RECORD OF DECISION AMENDMENT

Harbor at Hastings
Operable Unit Number 01: On-Site Contamination
State Superfund Project
Hastings-on-Hudson, Westchester County
Site No. 360022
March 2012

Prepared by
Division of Environmental Remediation
New York State Department of Environmental Conservation

FIGURE 2

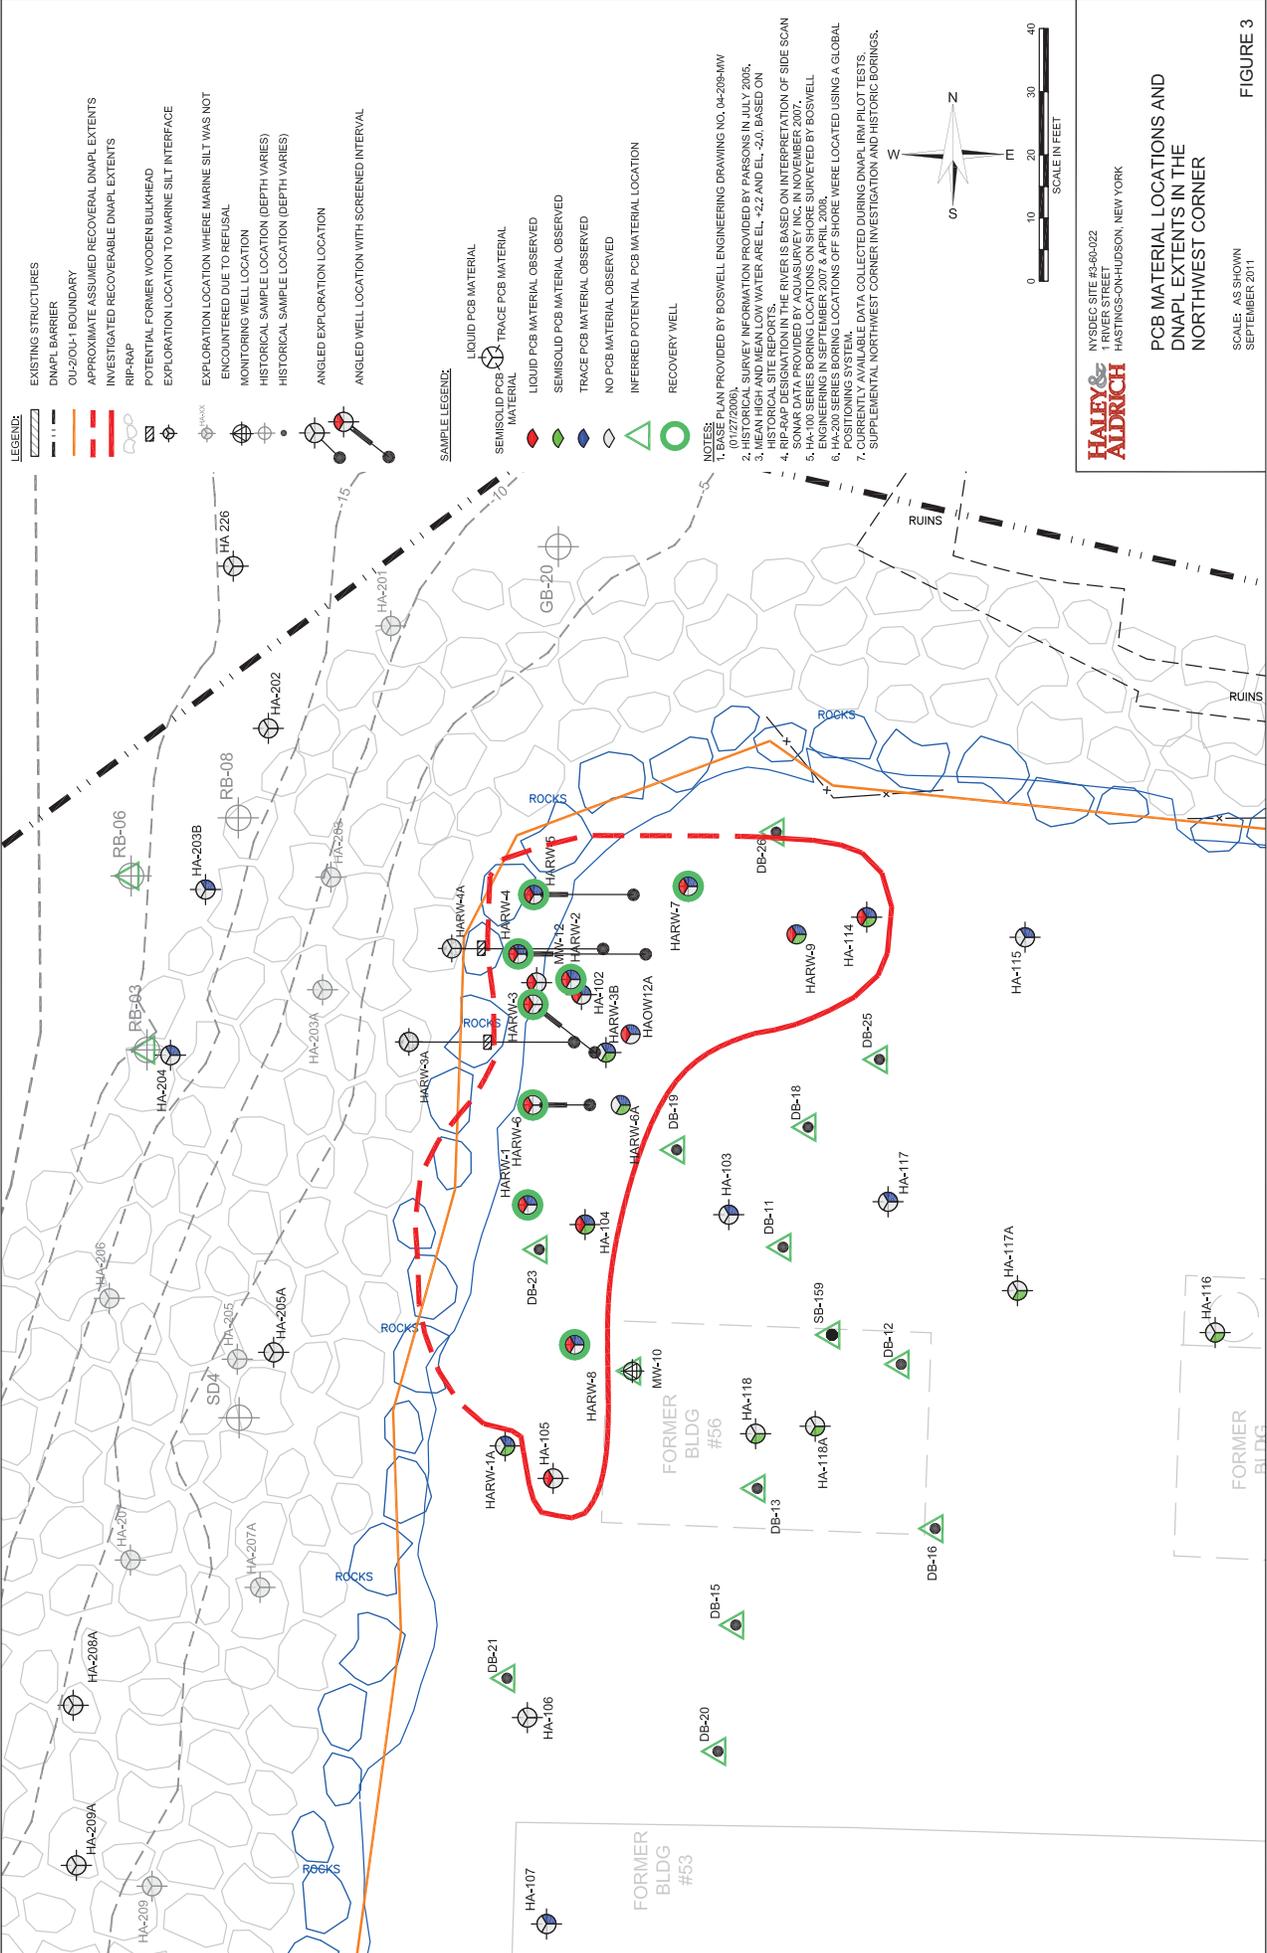
COMMENT 117: Element 2. Note that one of the “additional scope” items referred to in Section 8, Paragraph 7 is an expansion of the extent of excavation (and therefore the areas) in the Northwest Corner and Northern Shoreline areas (see Figure 2 comment below).

COMMENT 124: Figure 2. An updated version of Figure 2 that has been updated for the new data and uses the nomenclature in the text of the proposed modification is attached.

FIGURE 3

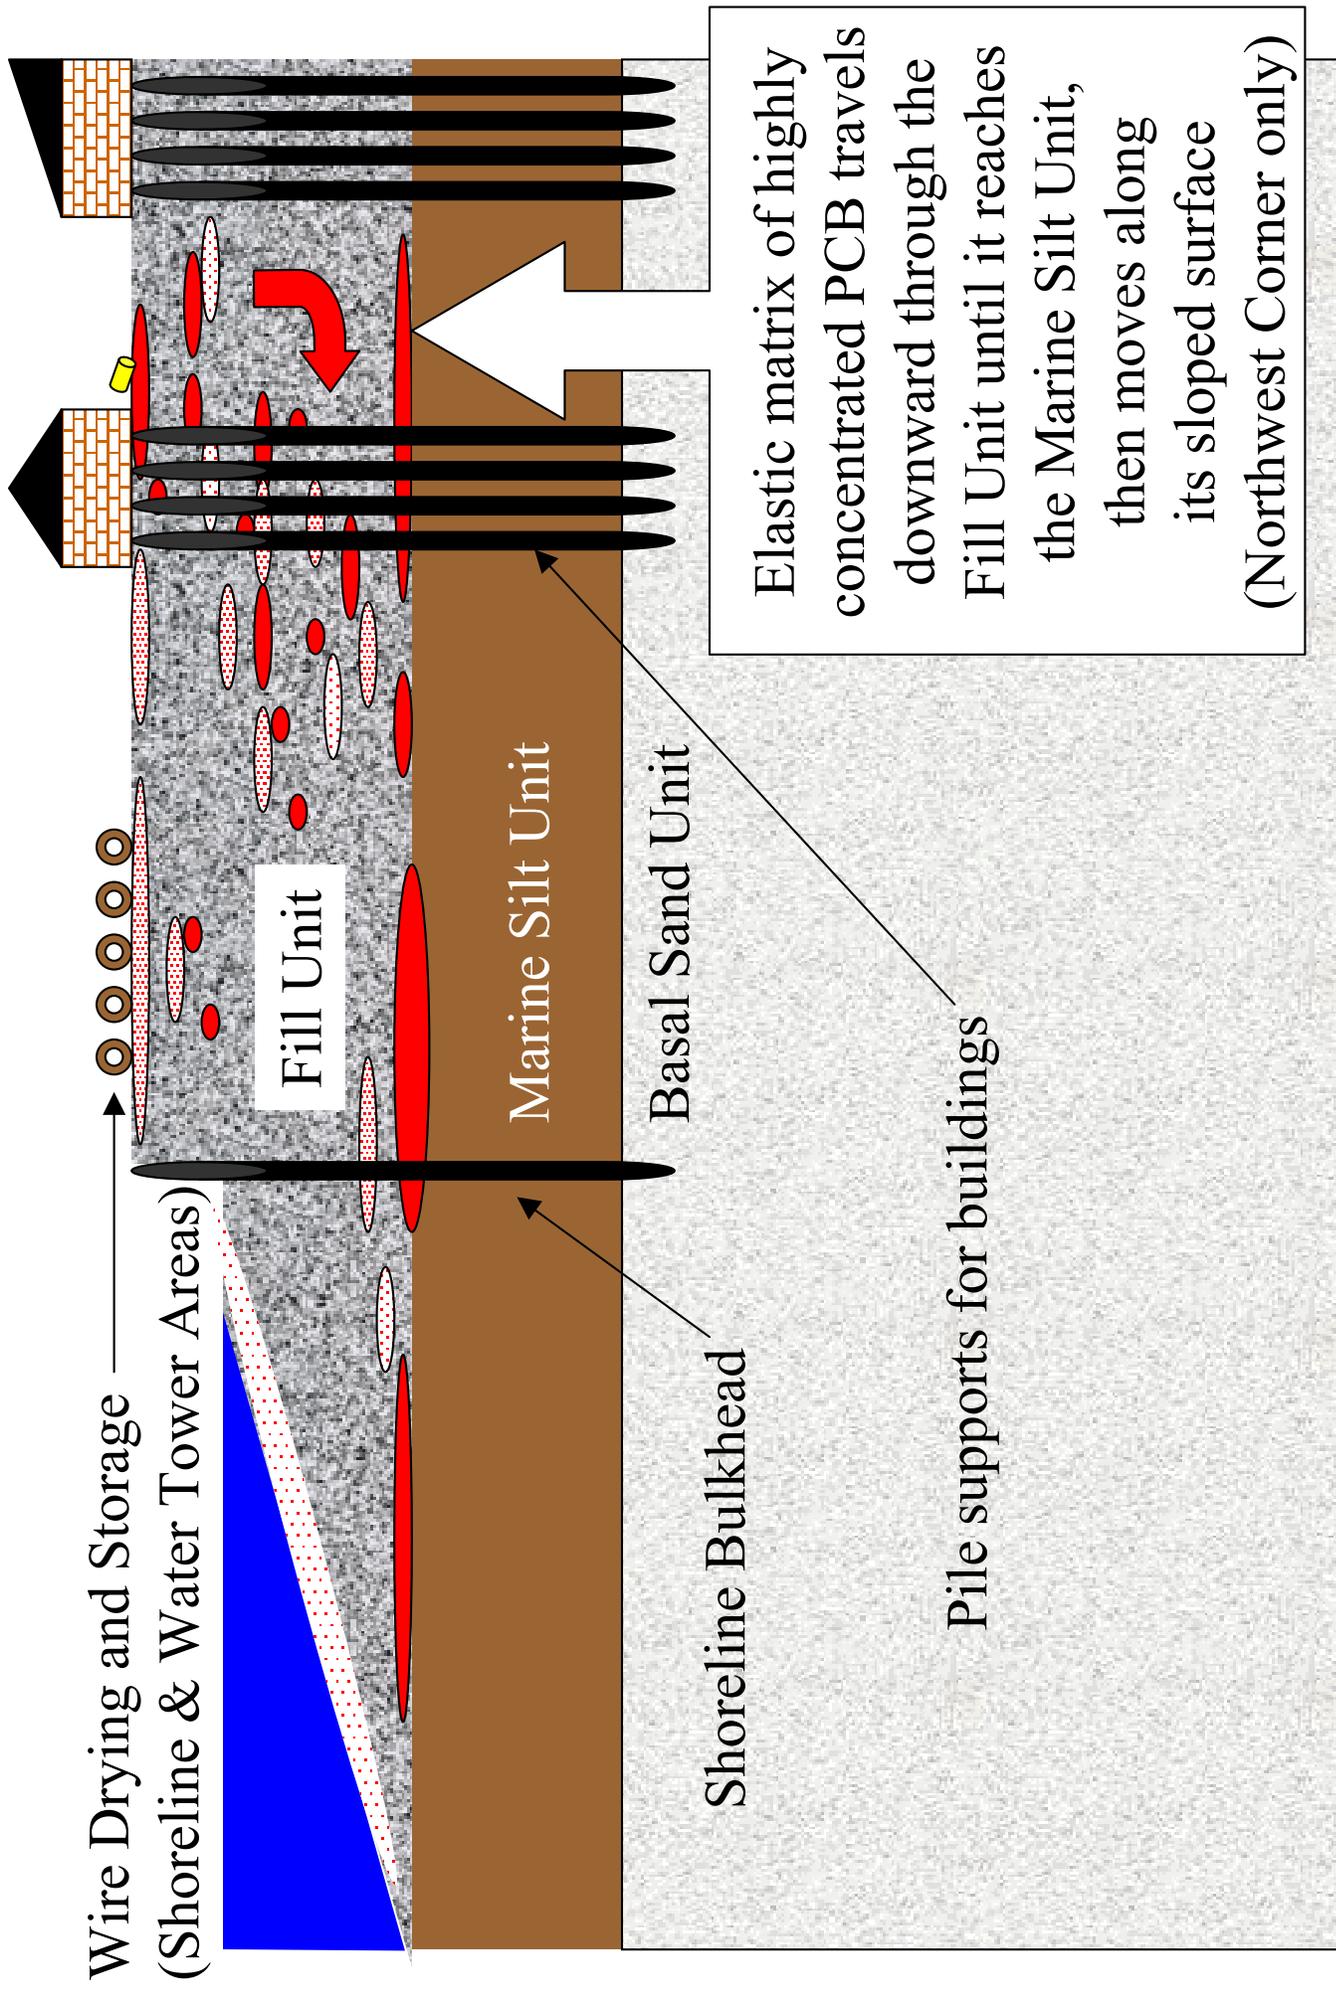
COMMENT 5: How much semi-solid PCBs are present beneath the river?

RESPONSE 5: The presence of semi-solid PCB has been identified in the areas shown on Figure 3 of the ROD. The full extent and amount of semi-solid PCBs present beneath the river has been difficult to estimate due to the difficulty in installing borings and sampling the area immediately offshore of the Northwest Corner. This area was not extensively sampled because the equipment needed to penetrate the rip rap could not access areas of shallow water under current conditions.
